Response-to-Comment to Drainage Impact Assessment Report

Section 12A Rezoning Application for Proposed Columbarium on Various Lots in D.D.41 Sha Tau Kok, New Territories

Drainage Impact Assessment Report

Reference: P036/02 Issue 5
Date: 12 February 2026
Confidential

Figure 3.2

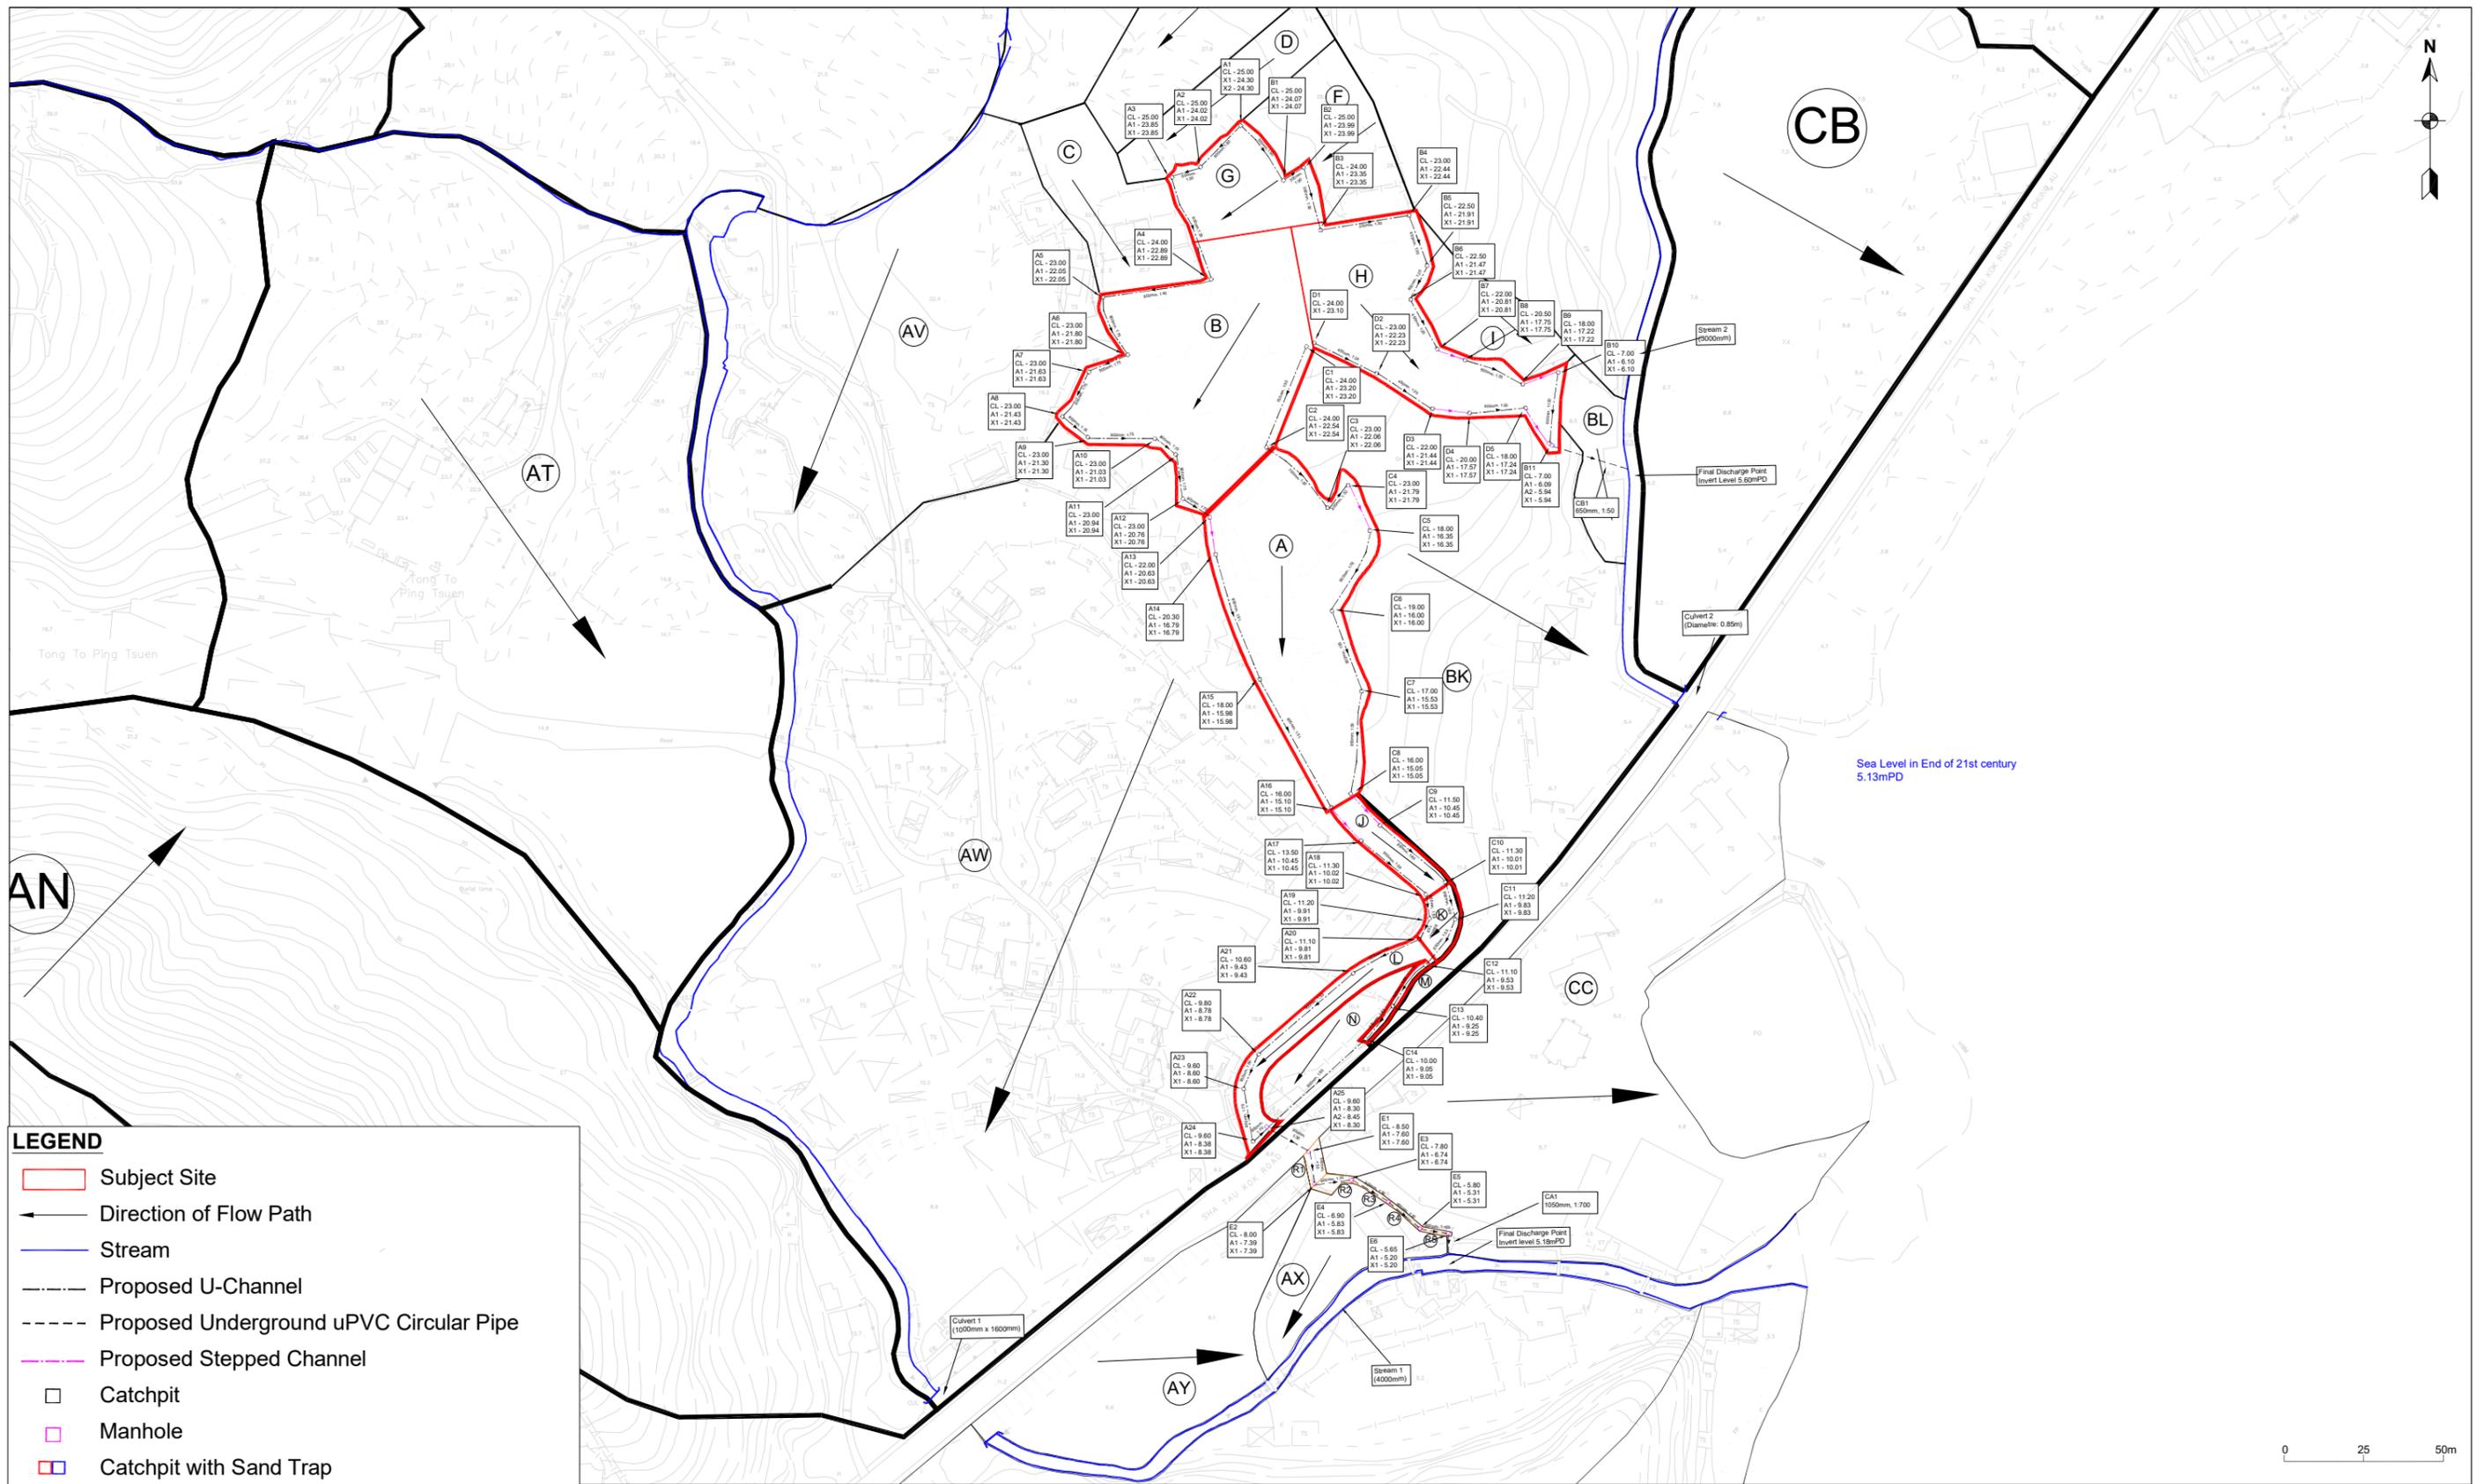
Items	Comments	Response
e	<p>Figure 3.2 refers.</p> <p>(i) The applicant should indicate the invert levels of the proposed catch pits and manholes.</p> <p>(ii) (ii) The applicant is reminded that the minimum cover from the surface of the carriageway to the top of the pipeline shall be 900 mm. For footway, the minimum cover shall be 450 mm.</p> <p>(iii) Manholes should be provided where a stormwater drain changes direction.</p> <p>(iv) The applicant should indicate the material of the proposed underground circular pipe.</p> <p>(v) The applicant should use a different legend for catch pit and manhole for clarity.</p> <p>(vi) The applicant should indicate the site formation levels and fall direction of the subject site.</p>	<p>(i) Noted and revised. Please refer to Figure 3.2.</p> <p>(ii) Noted. It is confirmed that the minimum cover from the surface to the top of the pipeline is 900 mm for the carriageway and 450 mm for the footway.</p> <p>(iii) Noted and provided. Please refer to Figure 3.2.</p> <p>(iv) Noted and indicated. Polyethylene pipe will be adopted for all proposed underground circular pipe.</p> <p>(v) Noted and revised. Please refer to Figure 3.2.</p> <p>(vi) Noted and revised. The details of Site formation level is provided in Appendix G.</p>

(b) The applicant should indicate the material of the proposed underground circular pipe on this figure.	Noted and revised. It is indicated that uPVC circular pipe will be adopted in Figure 3.2.

<p>(c) The applicant should add a legend for catch pit, which should be different from the legend for manhole.</p>	 <p>LEGEND</p> <ul style="list-style-type: none"> Subject Site Direction of Flow Path Stream Proposed U-Channel Proposed Underground uPVC Circular Pipe Proposed Stepped Channel Manhole Catchpit with Sand Trap <p>Noted. It is confirmed that there are different legends for manhole and catchpit. Please refer to Figure 3.2.</p>
	<p>(d) The applicant should indicate which sections of channel will be in the form of stepped channel.</p>	<p>Noted and revised. Please refer to Figure 3.2.</p>
<p>5</p>	<p>Appendix B refers.</p> <p>(a) The applicant should clarify how the surface runoff from catchment areas R1-R5 could be collected by the proposed drainage system which is underground.</p> <p>(b) As stream 1 would also collect surface runoff from the areas to the south of Sha Tau Kok Road (not just catchment R1-R5), the applicant should also consider these areas when checking the hydraulic capacity of stream 1.</p> <p>(c) The applicant should supplement hydraulic checking of the culverts underneath Sha Tau Kok Road (culverts connected to streams 1 and 2 circled in red below).</p>	<p>Noted and revised. The flow of R1 – R5 will be accumulated along the proposed circular pipe and will eventually enter the existing Stream 1 via CA1 pipe. Please refer to Appendix B.</p> <p>Noted and revised. The catchment located to the south of Sha Tau Kok Road has been included into the assessment. Please refer to Figure 3.2.</p> <p>Noted. The hydraulic calculation is provided in Appendix B with the site verification on 12 January 2026. Please refer to Appendix F for the photos of the culverts.</p>

(b) The 4th paragraph of Section 3.2 is incomplete. Please supplement.	The paragraph is duplicated and removed.
	(c) Figure 3.2 shows that the stormwater are discharged to Stream 1 and Stream 2 by underground pipe. However, it appears on Figures 3.8 and 3.9	Noted and revised. It is confirmed that the surface runoff from the Site is discharged to the two streams via a series of underground pipes. Please refer to Figure 3.10 and Figure 3.11.

Items	Comments	Response
Comments on Drainage Impact Assessment from DSD		
1	Figure 3.2 refers (a) The applicant should review the design of the proposed underground uPVC pipes as their tops protrude above ground levels (e.g. at manholes A25, E1). The applicant is reminded that the minimum cover from the surface of the carriageway to the top of the pipeline shall be 900 mm. For footway, the minimum cover shall be 450 mm. (b) The applicant should review the invert levels of catch pits and u-channels with consideration of thickness of concrete cover/grating to ensure the depths of u-channels are adequate. For instance, the depth of u-channel is less than 450mm at catch pit D2. (c) The applicant should review whether u-channels along the eastern and southeastern boundary of catchment areas J and K are required to intercept the overland flow. (d) The applicant should indicate the dimensions of the proposed stepped channels.	Noted and revised. The designed cover from the surface of the carriageway and footway to the top of the pipeline is at least 900 mm and 450 mm, respectively. Please refer to Figure 3.2 and Appendix B. Noted and revised. The thickness of the concrete cover/grating has been considered in the design of the invert levels of the catchpits and U-channels. Please refer to Figure 3.2 and Appendix B. Noted and revised. U-channels are proposed along the eastern and southeastern boundaries of Catchment J and K to ensure that all overland flow within the Site and upper catchments is collected by the proposed drainage system. Please refer to Figure 3.2 and Appendix B. Noted and indicated. Please refer to Figure 3.8A – Figure 3.8C.

Figure 3.6

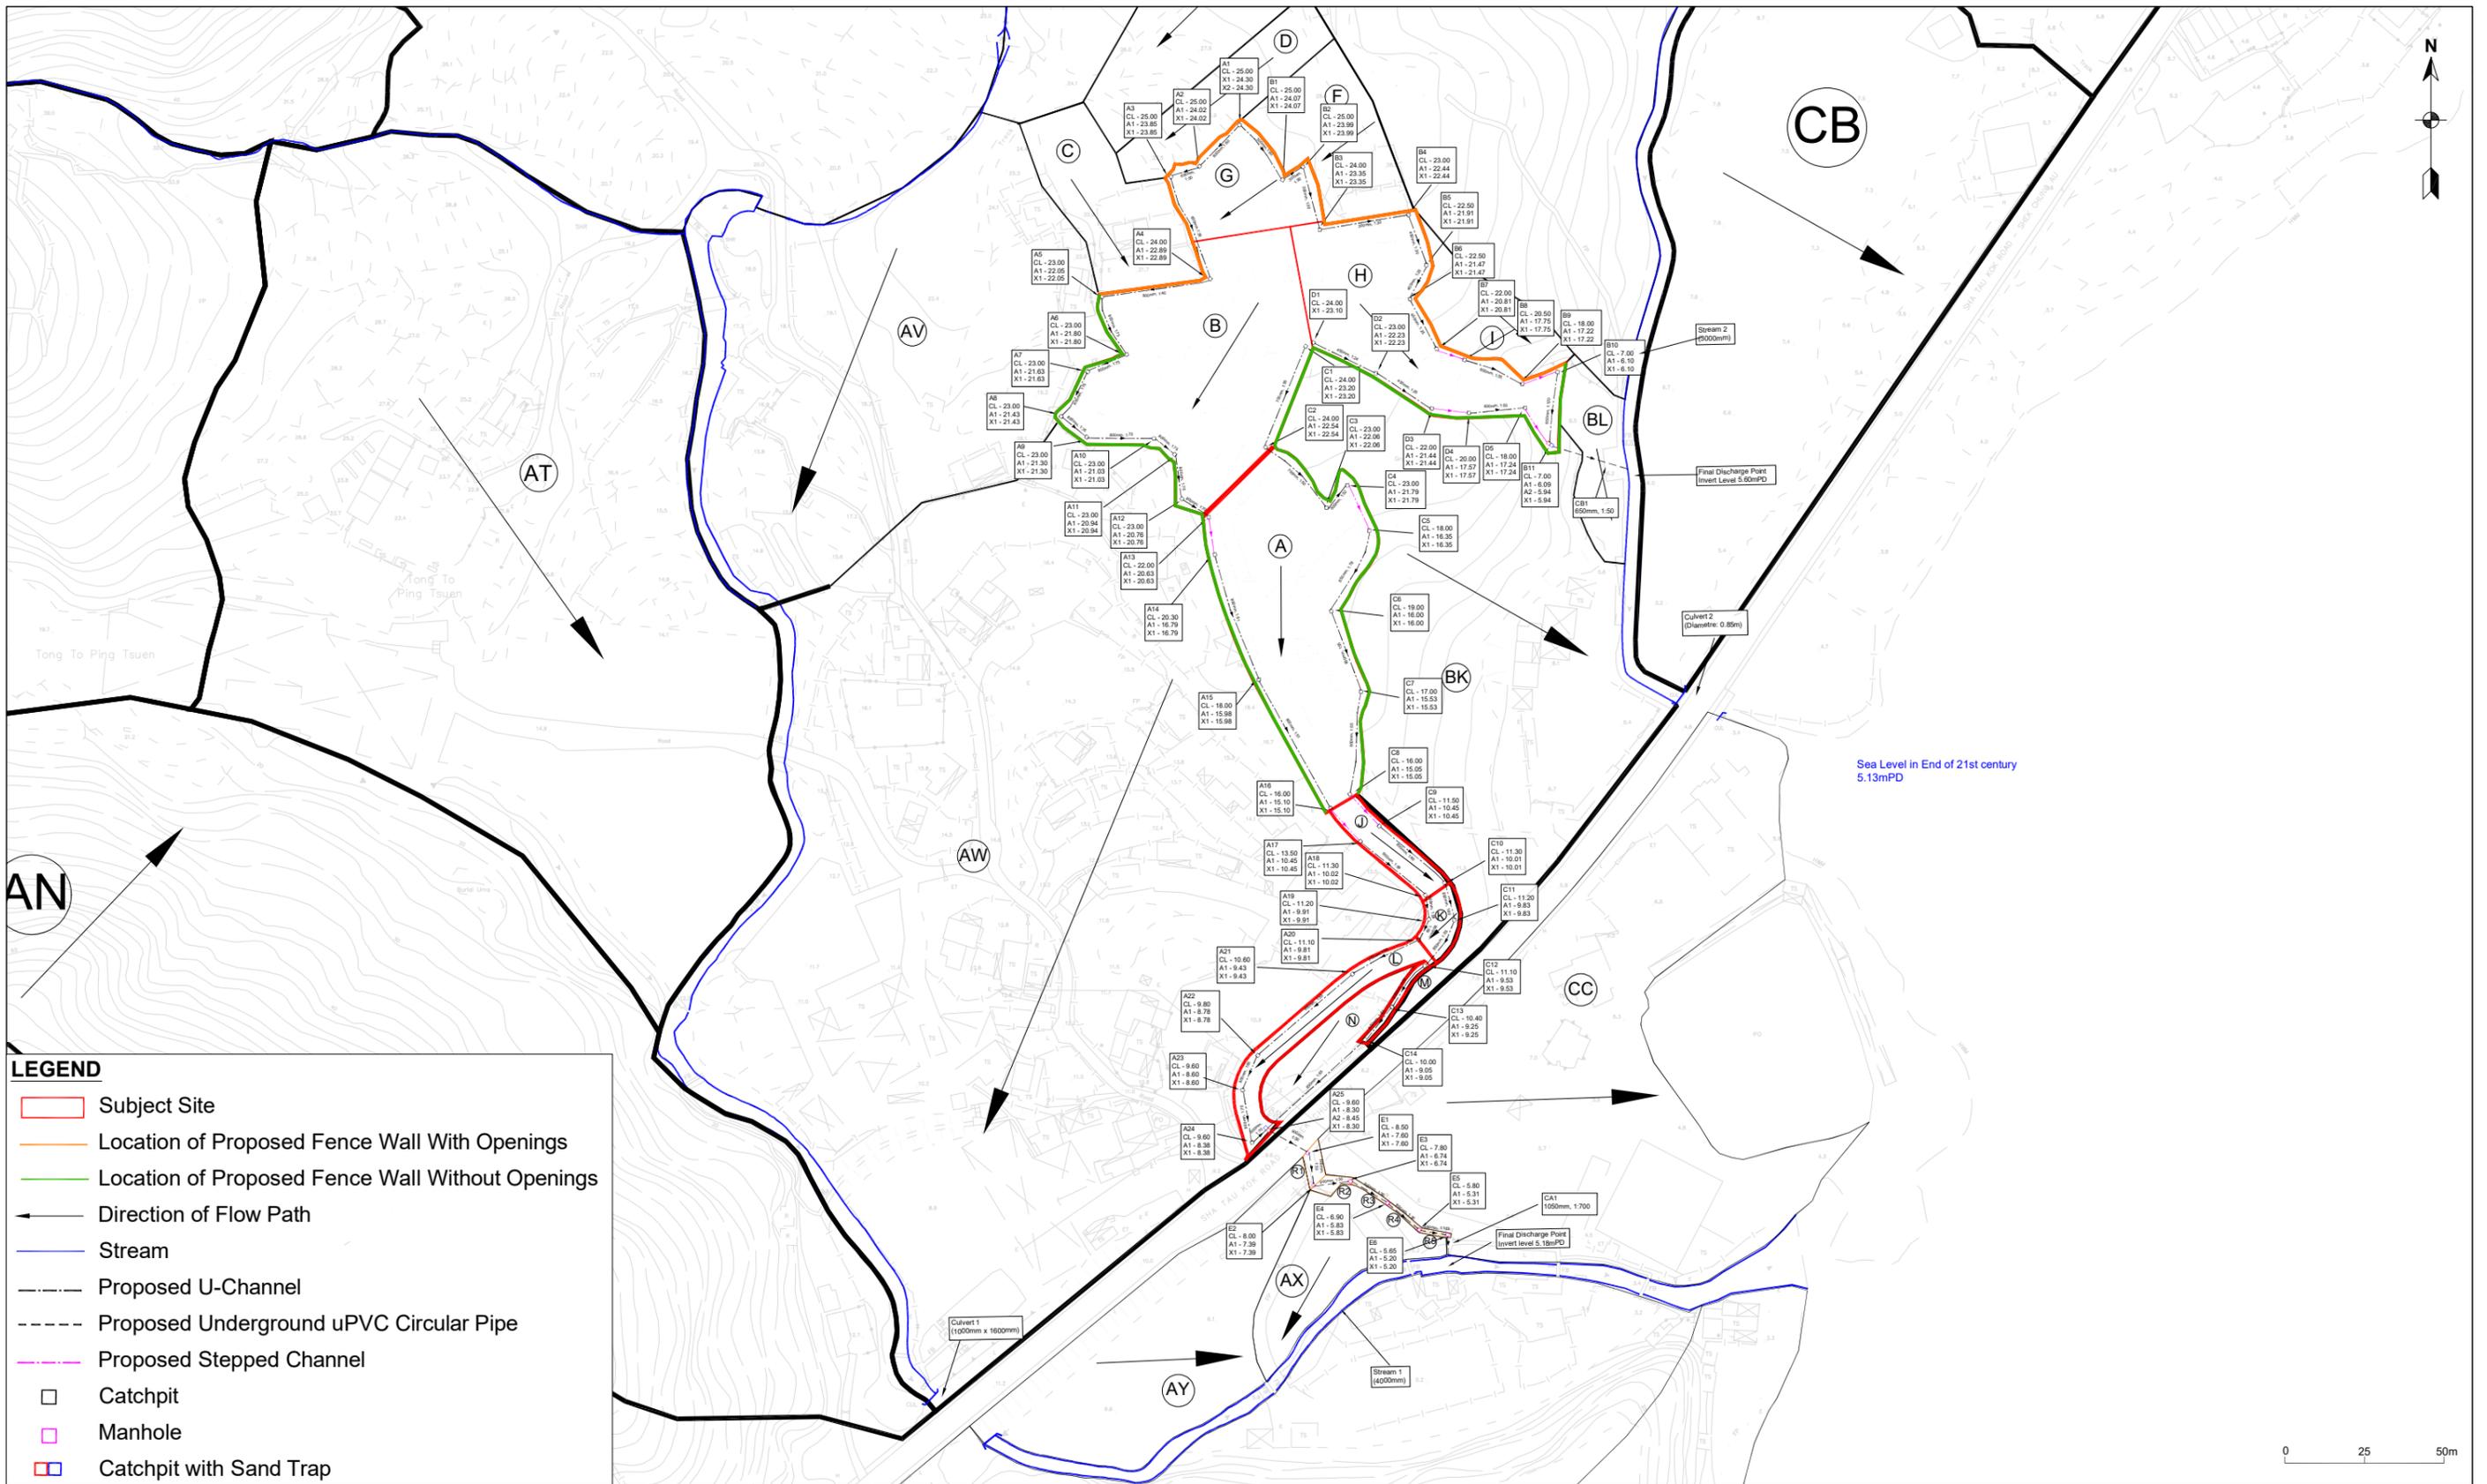
2	Figure 3.6: Both the orange and green lines represent fence wall without opening. The applicant should review.	Noted and revised. The orange lines represent the fence wall with openings, while the green lines represent the fence wall without openings. Please refer to Figure 3.6.
3	Figures 3.9A to 3.9G: The site boundary should be shown in these figures.	Noted and revised. Please refer to Figure 3.10A – Figure 3.10G.
